RE: **700 Tijeras**
700 Tijeras Ave NW
Grading and Drainage Plan
Engineer's Stamp Date: 6/12/19
Hydrology File: K14D117

Based on the submittal received on 6/14/19, the Grading and Drainage Plan cannot be approved until the following corrections are made:

Revisions Grading and Drainage C-101			Remarks
NO.	Date

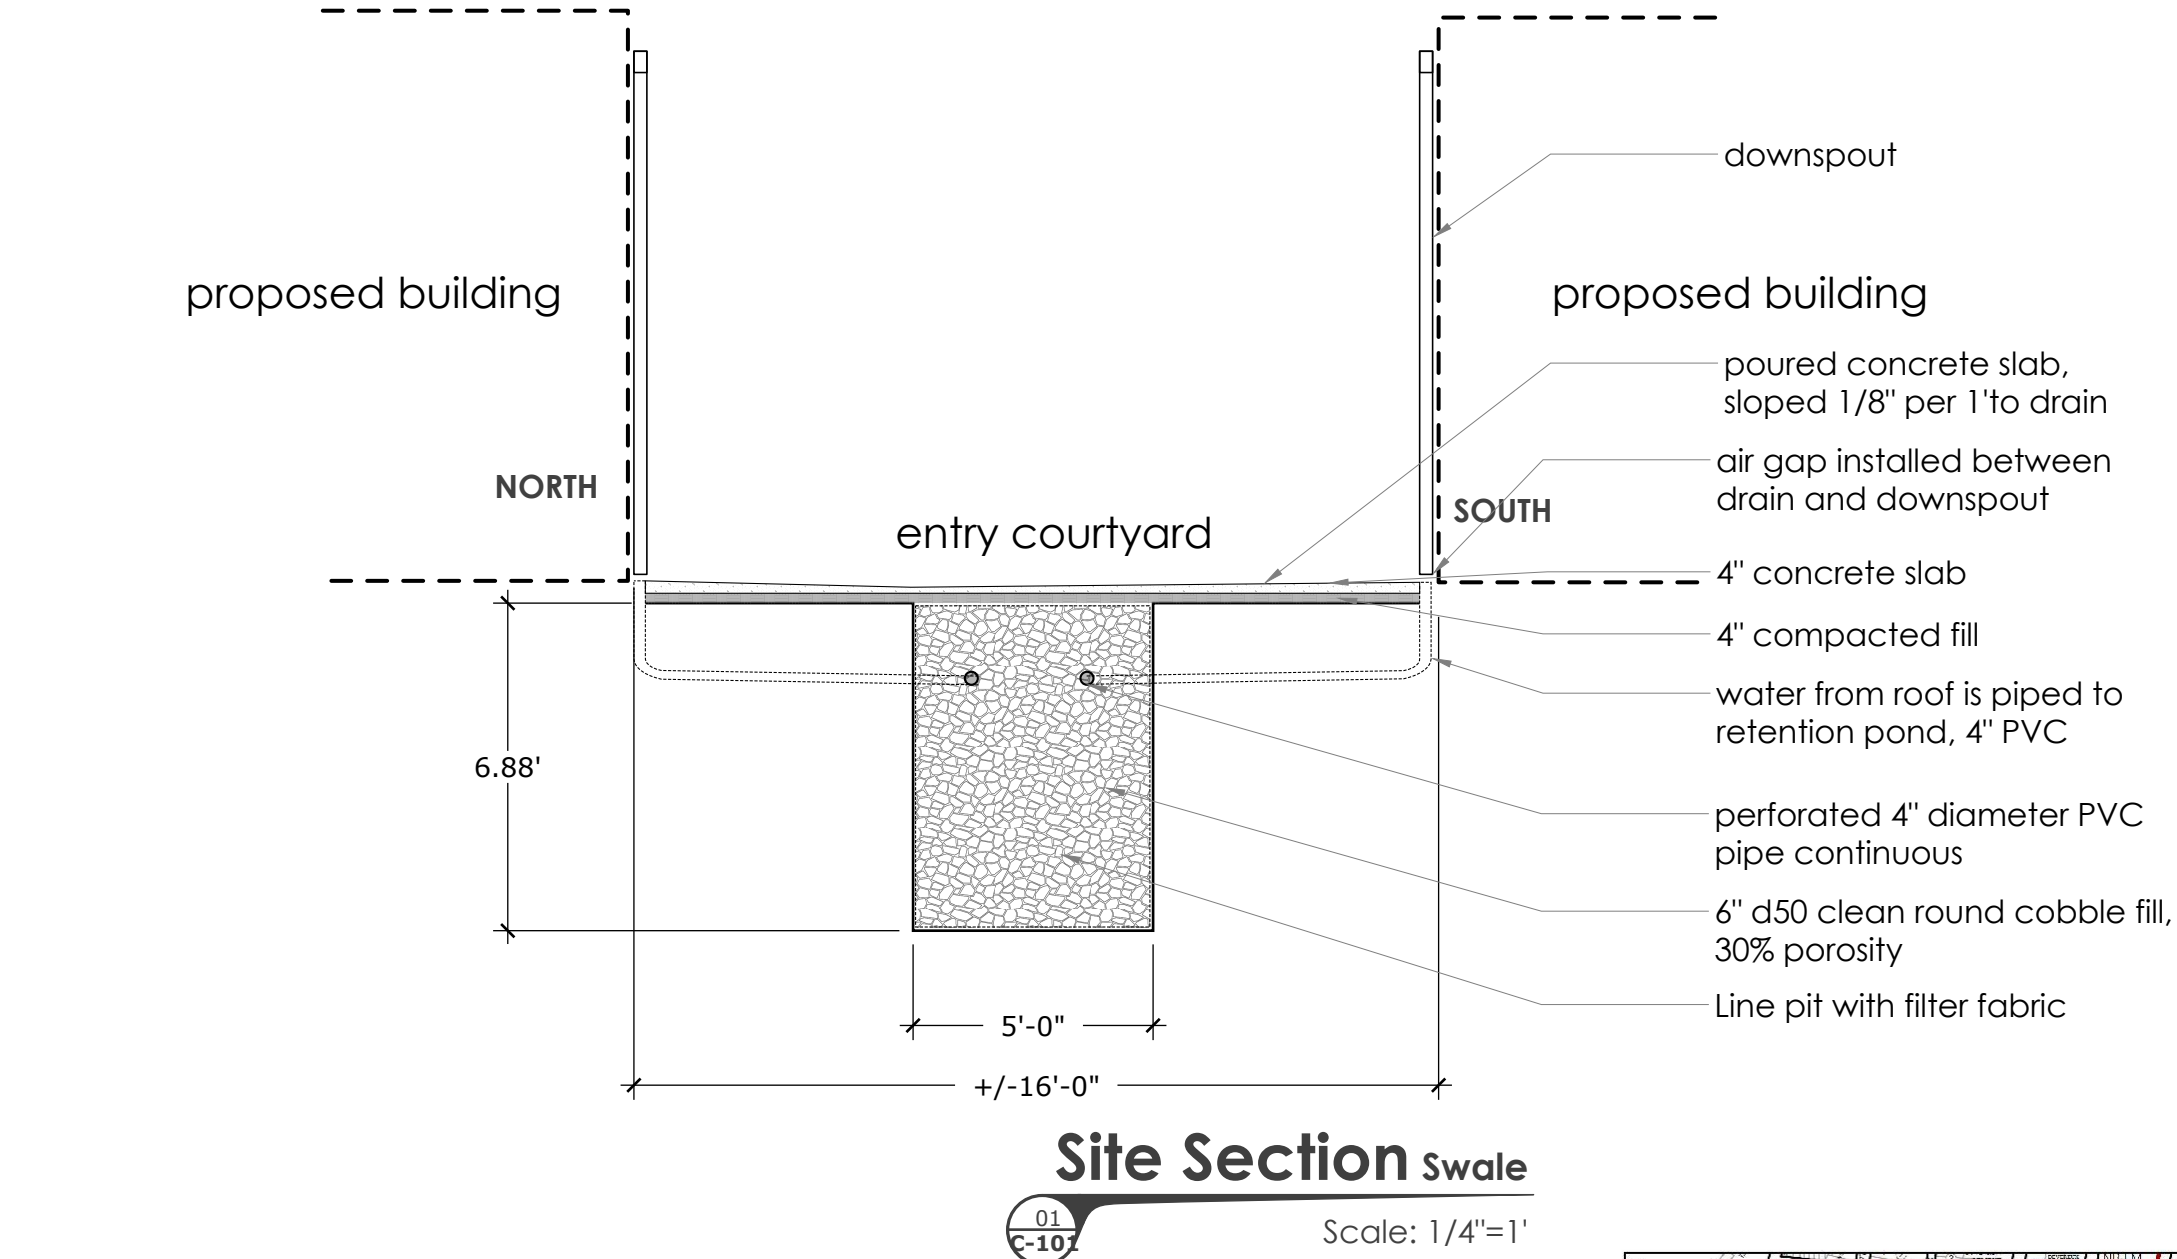
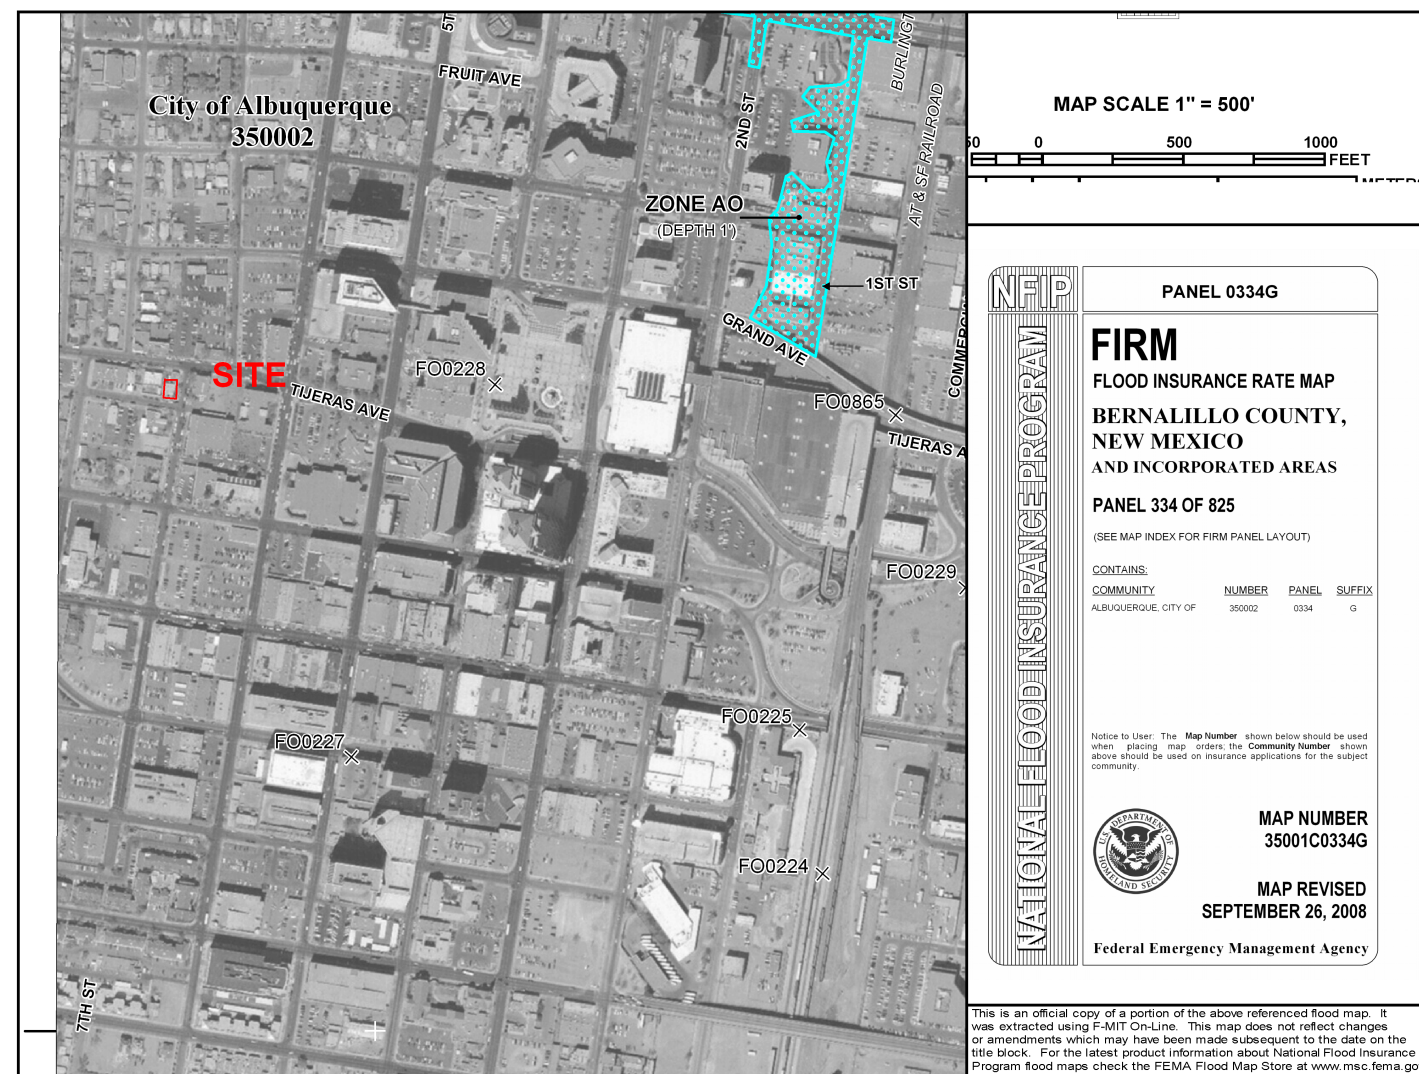
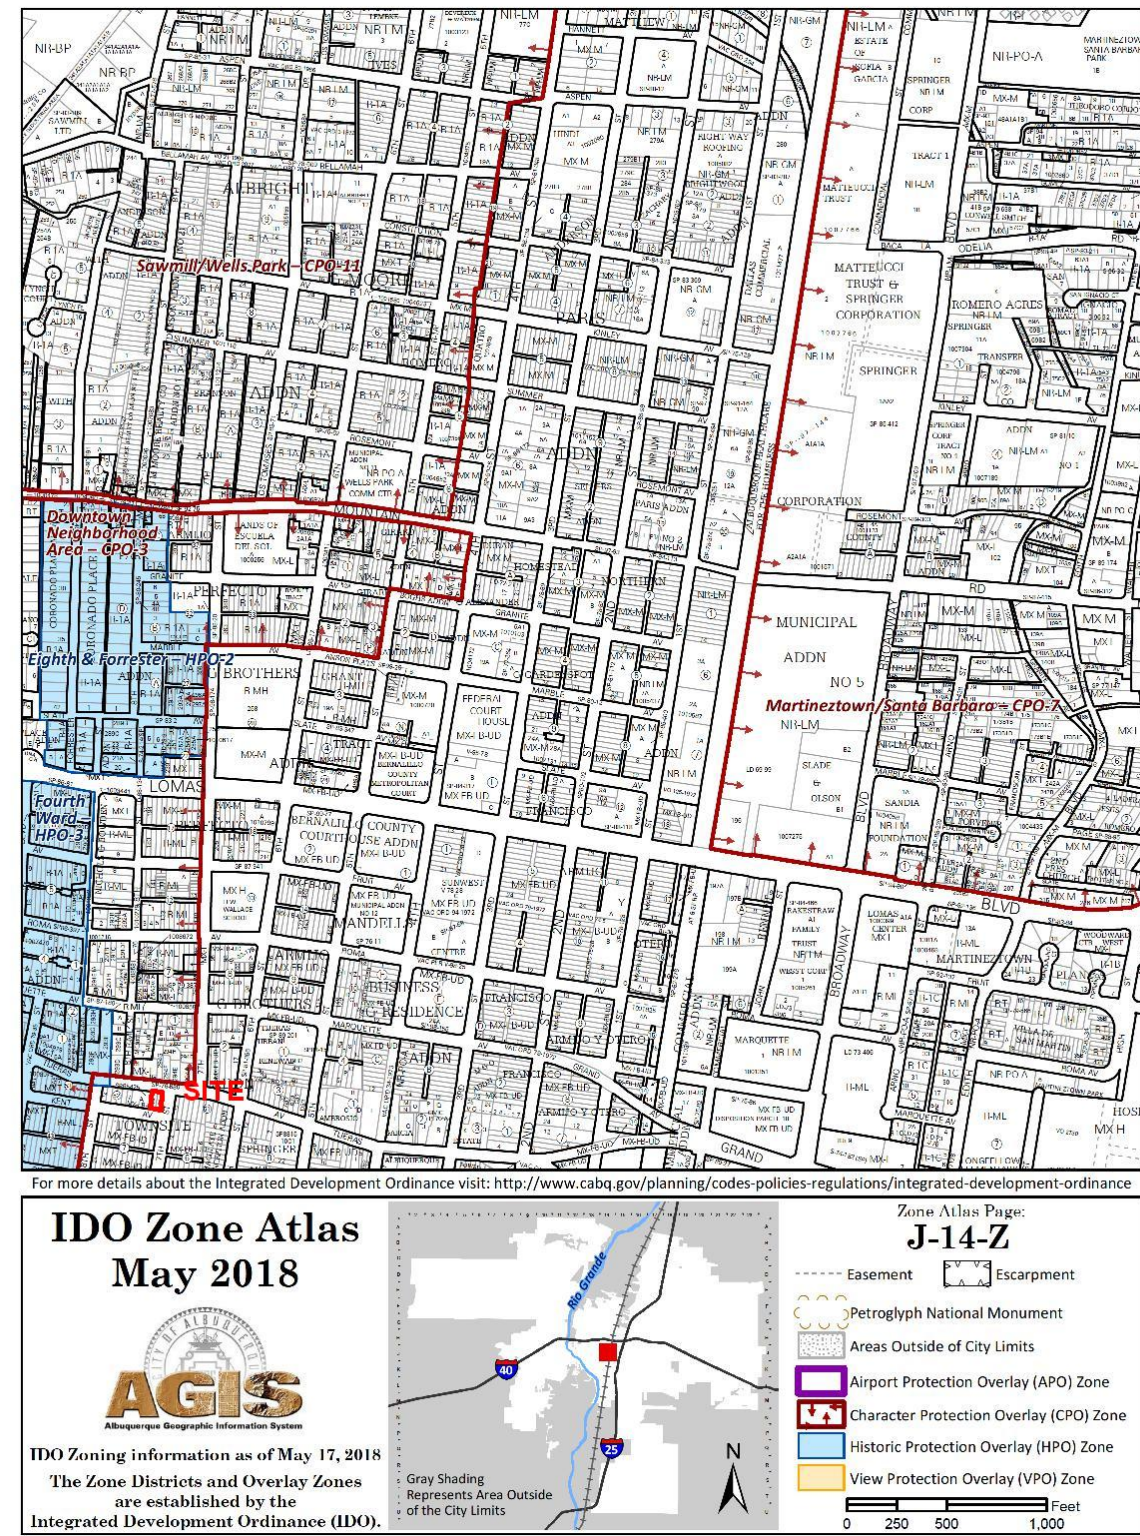
2. Include project benchmark and datum.
3. Provide existing site topography and label existing and proposed contours. Since the site is extremely flat, please provide spot elevations (existing and proposed) in enough density to verify the drainage areas and outfalls that you have indicated. Also include the finished floor elevation of the buildings.

4. Provide sections through the external boundaries showing proposed retaining walls, garden walls, property/ROW lines, existing and proposed grades. In accordance with DPM Ch.22, section 5 part B, grading and wall construction near the property line may not endanger adjacent property or constrain its use.

5. Include the finished elevation for the courtyard slab and show how it will drain with slopes and spot elevations. It seems to drain to the middle, then east towards the trench drain, but this is unclear on the plan.

6. Remove the note that a Pad Certification will be required; Hydrology will just inspect at the time of C.O.
